COMMITTEE OF ADJUSTMENT

MINOR VARIANCE REPORT

APPLICATION: CAV A/174/2024

CAV A/174/2024 - 412 Silver Maple Rd (East District) (Urban Core Area)

Examples of proposed reduction:

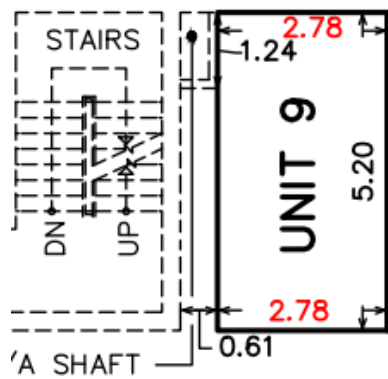
Unit 51- Reduction due to wall

Unit 9- Reduction due to A=a shaft

The proposed reduction in size does not create any undue adverse impact to the functionality, however; the potential buyer might need to adjust how they approach the parking spot, such as reverse parking for optimal use.

Example of the proposed reduction:

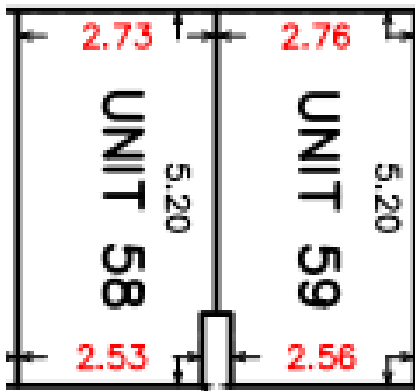
The applicant is proposing a reduction in dimension from 2.6 the following due to column obstruction:

Unit 58 and 59 – Reduction due to column
